STAFF REPORT SAN CLEMENTE PLANNING COMMISSION

Date: May 20, 2020

SUBJECT: **Site Plan Permit (SPP) 19-203, Architectural Permit (AP) 19-204, Conditional Use Permit (CUP) 19-205, Amended Discretionary Sign Permit (AM-DSP) 18-546, 610 Camino De Los Mares; Plaza by the Sea Drive-Through**, a request to demolish a freestanding commercial building and construct a new 4,250 square foot commercial building for two tenants including a drive-through in an existing commercial center at 610 - 628 Camino De Los Mares within a city Gateway and the Community Commercial 4 Zone (CC4). A dividing wall between Plaza by the Sea and neighboring Ocean View Plaza (638 Camino De Los Mares) is proposed to be removed to allow for shared access between the retail centers. The recently approved Master Sign Program is proposed to be updated to include signage for the new building including a drive up menu-board.

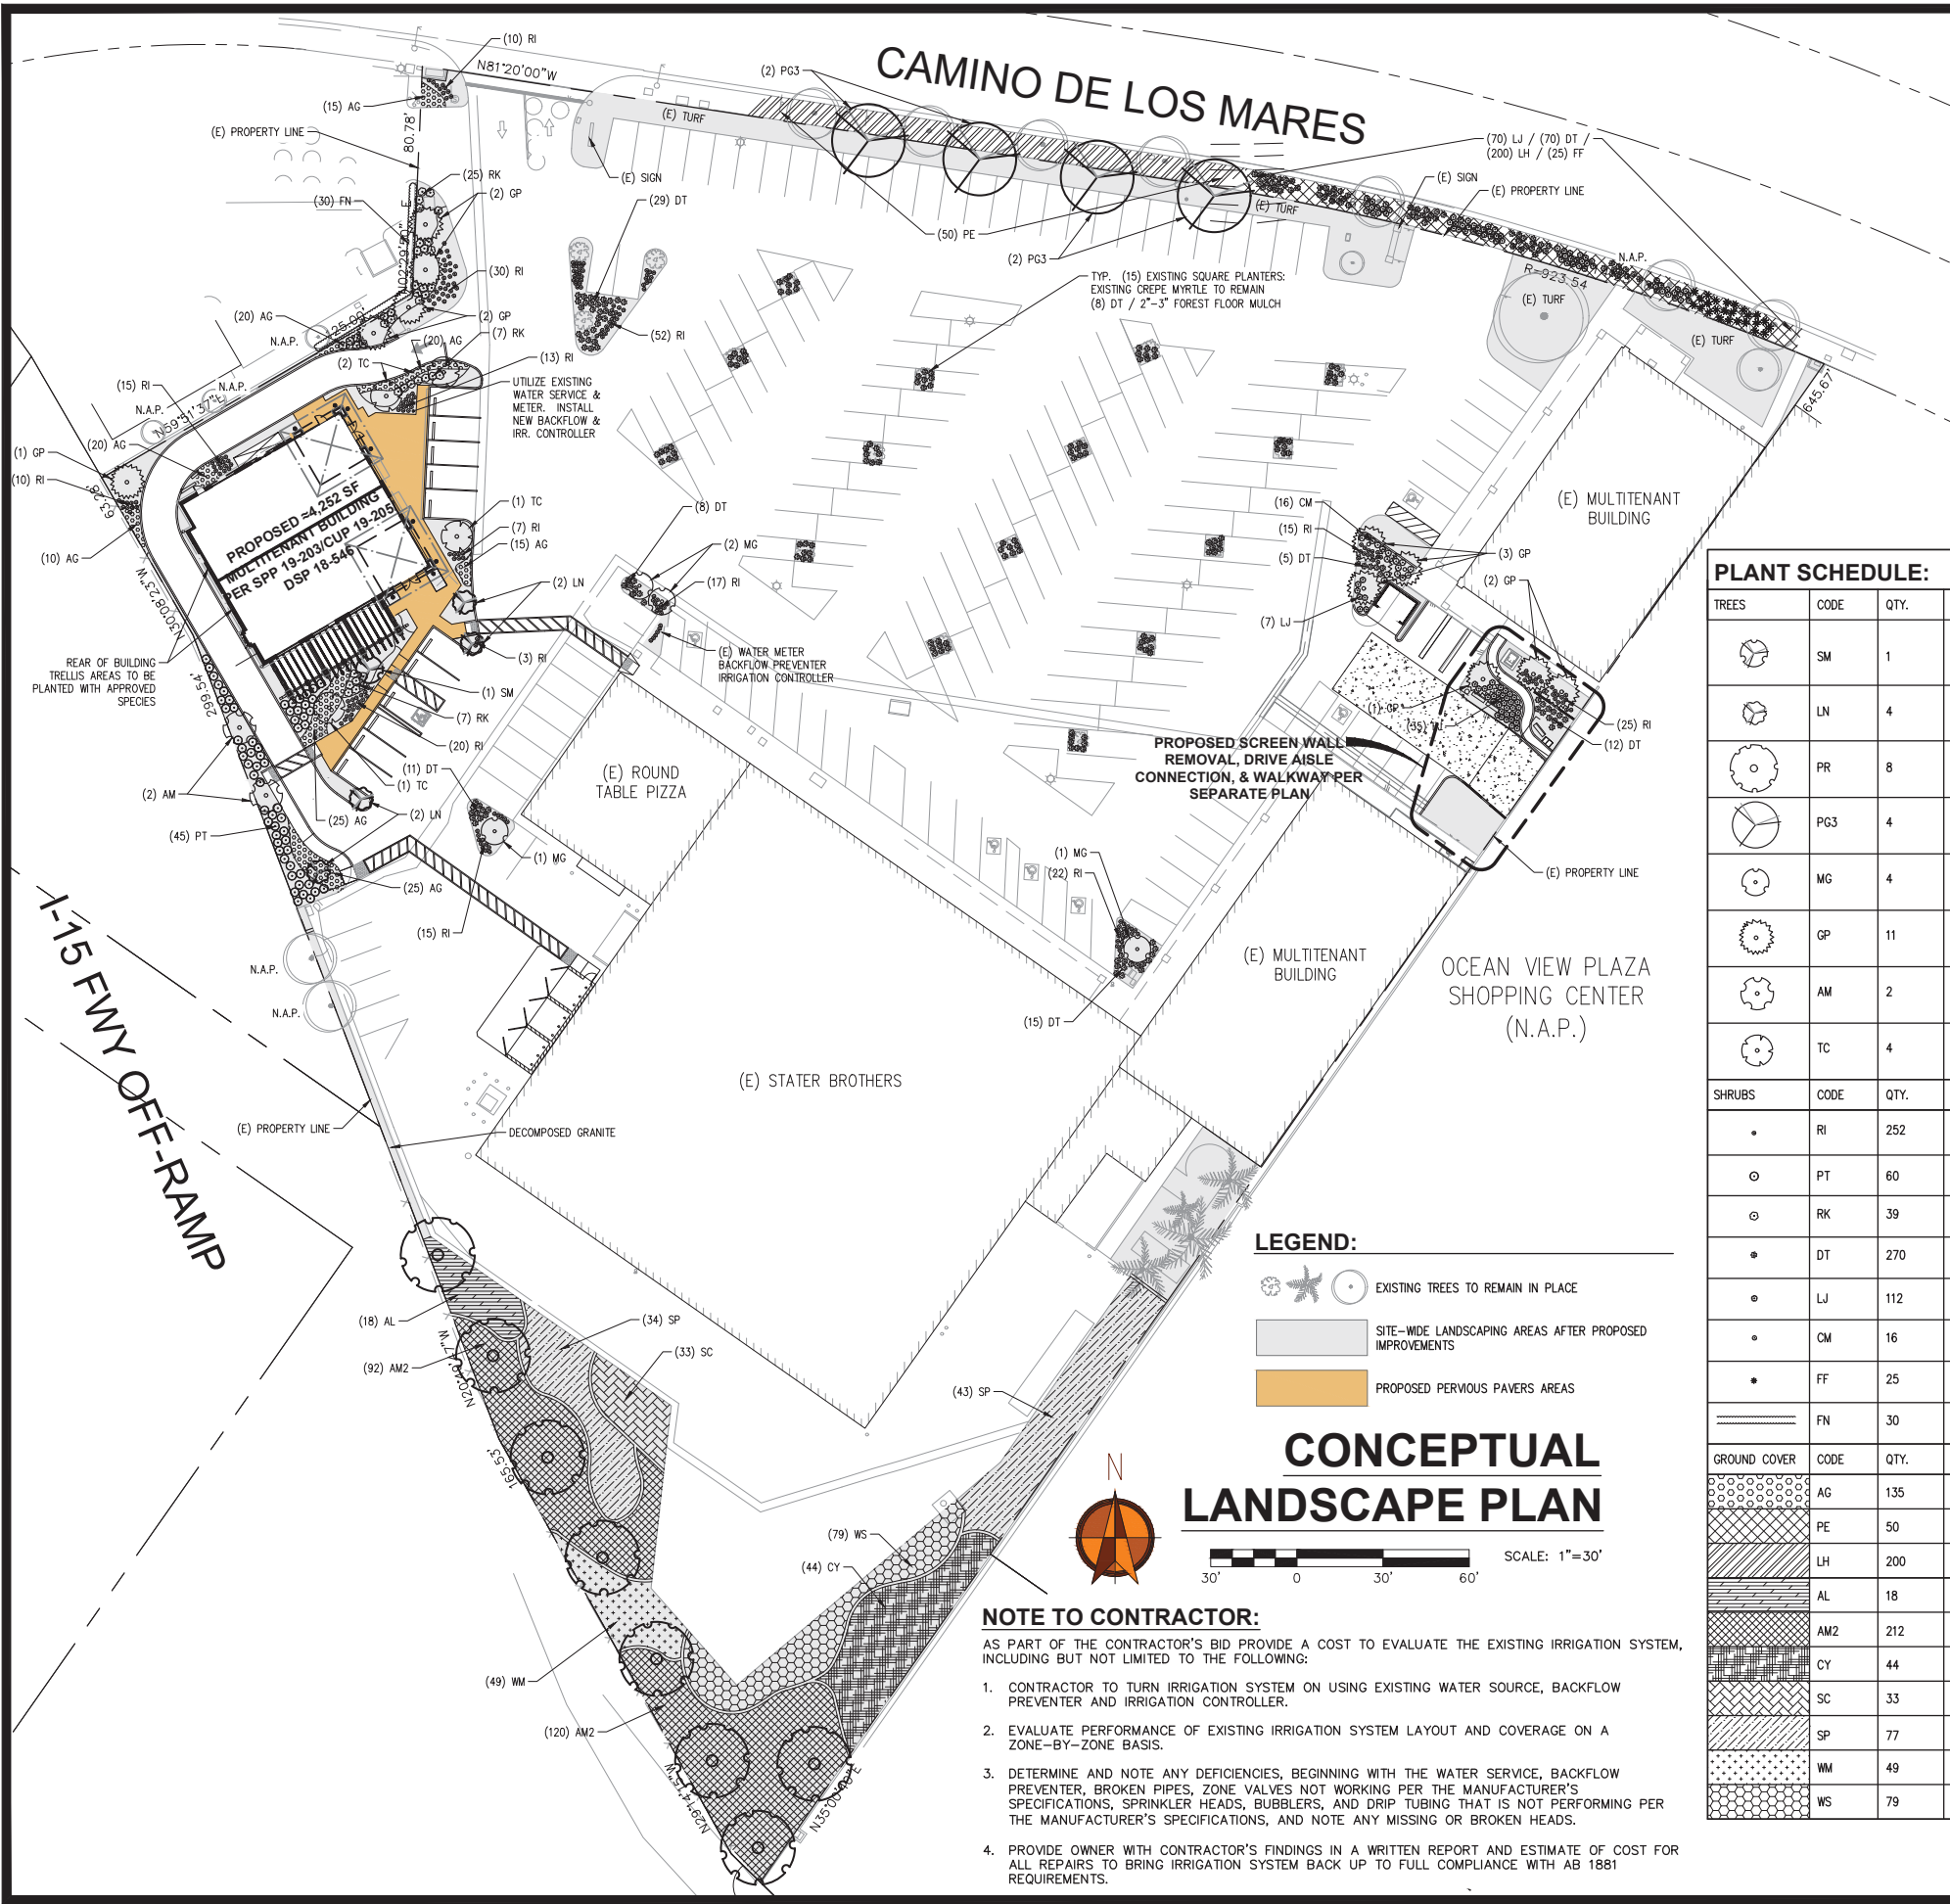
6. Recommended incorporating furniture items, such as benches or bike racks, would be an appropriate amenity.	Addressed. See plan sheets SP1 and LS1: bike racks and benches for seating have been added.

NORTHWEST ELEVATION
SCALE: 3/16"=1'-0"

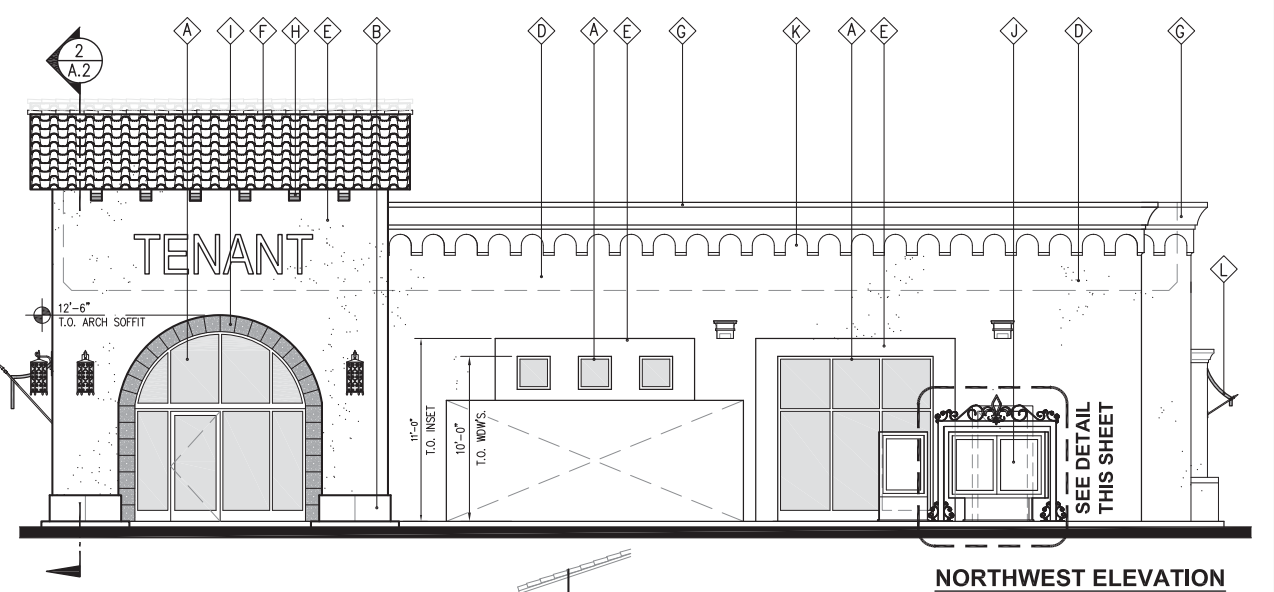
5. Noted that required EVCS parking and related equipment should be shown on the site plan and integrated to minimize the visibility of the equipment.	Addressed. See plan sheet SP.1. Equipment (other than charging unit) shall be mounted to the building behind the stucco wall shown on the northwest elevation.

DRIVE-THRU MENU BOARD DETAIL
N.T.S.

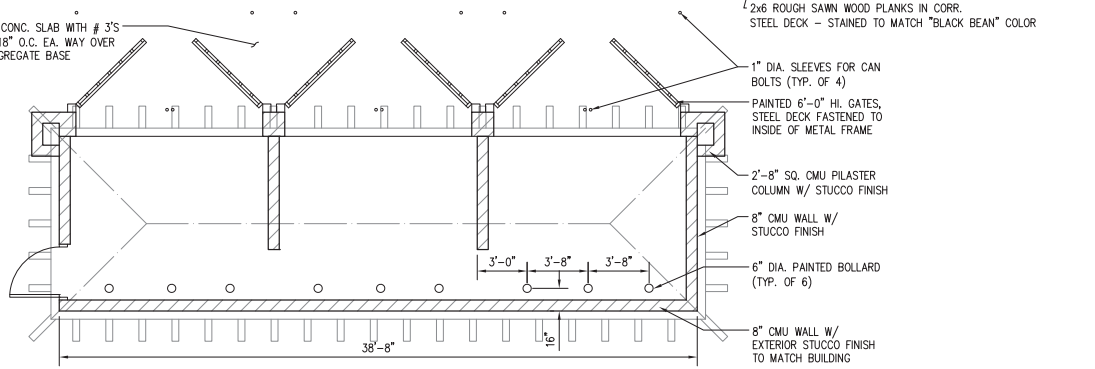
4. Discussed menu board and directional signage for the future drive-through restaurant and recommended using design elements that are compatible with building.	Partially addressed. Menu board signage with decorative wrought iron freestanding frame shown in plans; directional signage is indicated, but not illustrated.

- d. The proposed menu board is located directly adjacent to the proposed queue and is appropriately sized to provide menu information for drivers. As electronic menu boards are procured through third parties, the applicants have designed a detached decorative wrought iron frame to blend the sign with the SCR style of the building.
